STATION, RADIO, A40

TECHNICAL HANDBOOK - INDEX OF MODIFICATIONS

TELECOMMUNICATIONS
F 467 Mod Instr No 1

SUB-TITLE: Retention device for audio plug

Fig 1 - Front panel flange - drilling detail

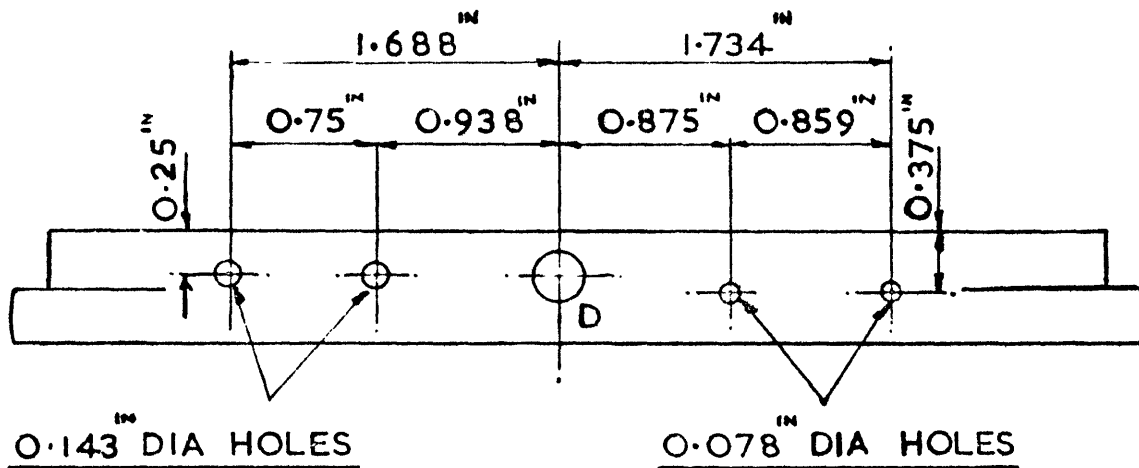
The audio plug of the Transmitter-receiver, radio, A40 (TR A40) is very easily removed from its socket, in some instances the fit being so poor that it virtually drops out. This regulation details the fitting of a retention clip for the audio plug and must be carried out before the plugs of Telephone, hand SI, No 4G, and Microphone and receiver headgear assembly, SI, No 1A, which are used with the TR A40, are modified as per Tels C 727 Mod Instr No 2 and 3 respectively.

- (a) Remove the two self-tapping screws which secure the modification record plate and remove the plate.
- (b) Drill two holes 0.078 in. diameter (No 47 drill) on the opposite side of the flange so positioned that their centres are 0.375 in. from the top of the flange and 0.875 in. and 1.734 in. respectively from the centre of the 0.188 in. hole in the middle of the flange.

- (c) Place the modification record plate (removed at (a)) in this new position and secure it with the original two self-tapping screws.
- (d) Drill two 0.143 in. diameter holes (No 27 drill) on the l.h. side of the flange so that their centres are 0.25 in. from the top of the flange and 0.938 in. and 1.688 in. respectively from the centre of the 0.188 in. hole in the middle of the flange.

- (e) Fit the retainer (ZA 55021), provided, over the two holes drilled at (d) and secure it with the No 4 BA screws and nuts provided.
- (f) Strike through the figure 3 on the TR A40 modification record plate with a diagonal line.

Fig 1 - New antenna socket -
assembly detail

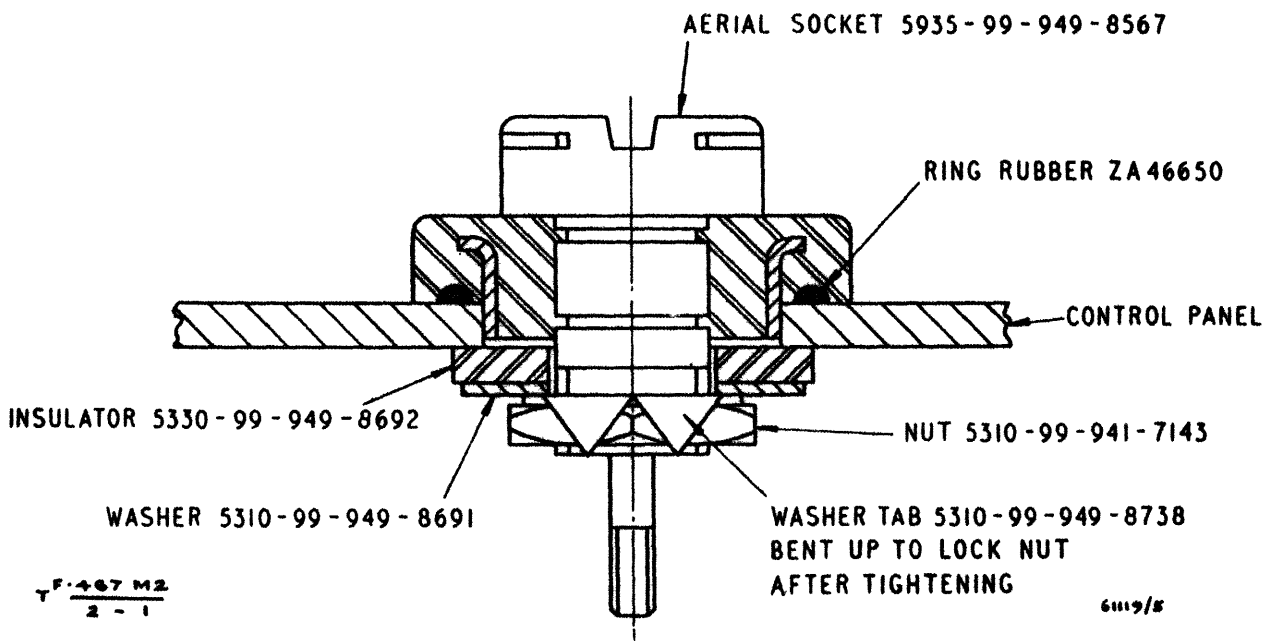
Numerous reports have been received that the antenna socket on the front panel of Transmitter-receiver, radio, A40, becomes loose and rotates when subjected to twisting forces such as occur during normal use in the field. When such movement occurs, the antenna coil connection might become wrenched off and the coil itself damaged. This regulation details the fitting of an improved socket assembly to overcome these defects.

- (e) Assemble the new antenna socket assembly on to the panel as shown at Fig 1. Apply a light coat of Grease, silicone, MS4 (XG-250) to the sealing ring ZA 46650 before fitting.

Fig 1 - Coupler antenna - assembly detail

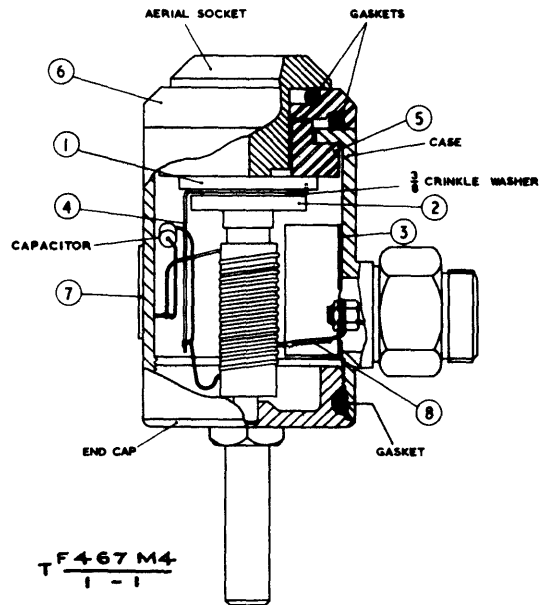
If the insulators of Coupler, antenna (Z1/ZA53400) which is used with Transmitter-receiver, radio, A40, compact to the extent that the antenna socket securing nuts become loose, the antenna coil connectors are liable to be wrenched off when the antenna is being fitted due to movement of the socket. This regulation details the action required to give greater mechanical security to the assembly, and also the fitting of a modification record label to the case.

- (1) Pass the antenna socket through the insulating washer (item 6), then through the aperture in the top of the case.
- (2) Reverse the case and fit the insulating bush (item 5) over the antenna socket so that the end of the bush passes through the case aperture.

- (3) Fit the special nut (item 1) on to the antenna socket and, when tightening, ensure that the bush remains located in the case.
- (4) Fit the tag (item 4) so that the tail is positioned opposite the mark made at b.(1), and the tab is engaged in the hole provided for it in the nut.

- (5) Refit the crinkle washer from the original assembly.
- (6) Fit the special nut (item 2).
- (7) Refit the coil so that the tapped end is furthest from the antenna socket, the tap is opposite the mark on the case made at b.(2) and the spigot on the end of the former is in the indentation at the end of the antenna socket.

- (8) Solder the antenna socket end of the coil and the appropriate end of the 15pF capacitor to the earth tag on the inside of the case. Solder the far end of the coil and the other capacitor lead to the tail of the tag (item 4).

Fig 1 - Location of screws requiring washers

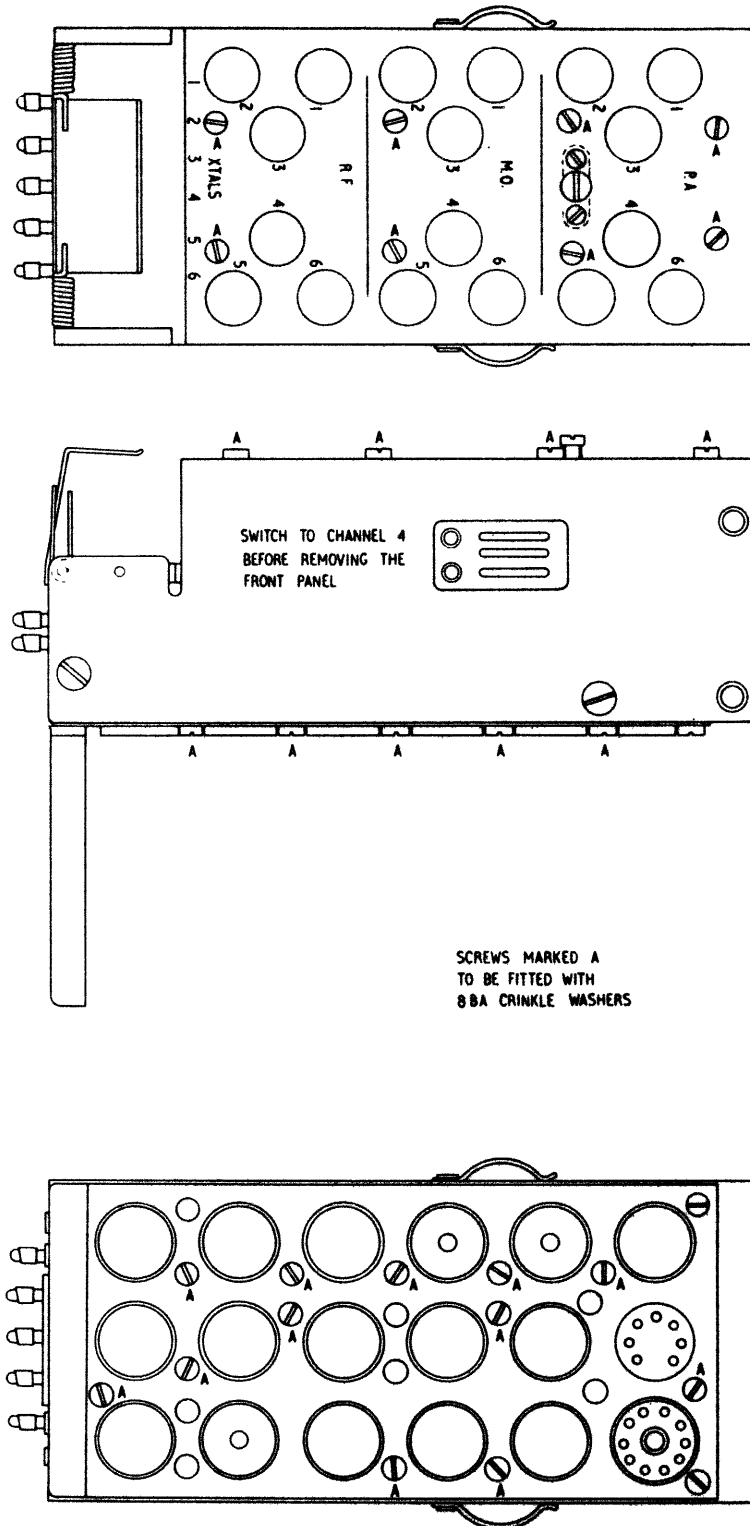
A number of No 8 BA screws used on the Transmitter-receiver, radio, A40, A40A or A40B valve decks and trimmer covers, tend to become loose in service. The remedy is to fit crinkle washers under the heads of the screws concerned. This regulation details the action required to fit the washers. This modification must be carried out together with Tels F 467 Mod Instr No 5.

- a. Remove the Transmitter-receiver, radio, A4O, A4OA or A4OB from its case.
- b. Refer to Fig 1 and identify the twenty screws on the valve deck and trimmer cover. The screws are marked with the letter A on the diagram.
- c. Remove plug-in units as necessary to allow the No 8 BA screws to be removed.
- d. Remove each screw in turn, fit a crinkle washer under the head and replace the screw.
- e. Replace the plug-in units, then replace the equipment in its case.
- f. Record the modification by striking through with a diagonal line the figure 6 on the modification record plate of the Transmitter-receiver, radio, A4O, A4OA or A4OB.
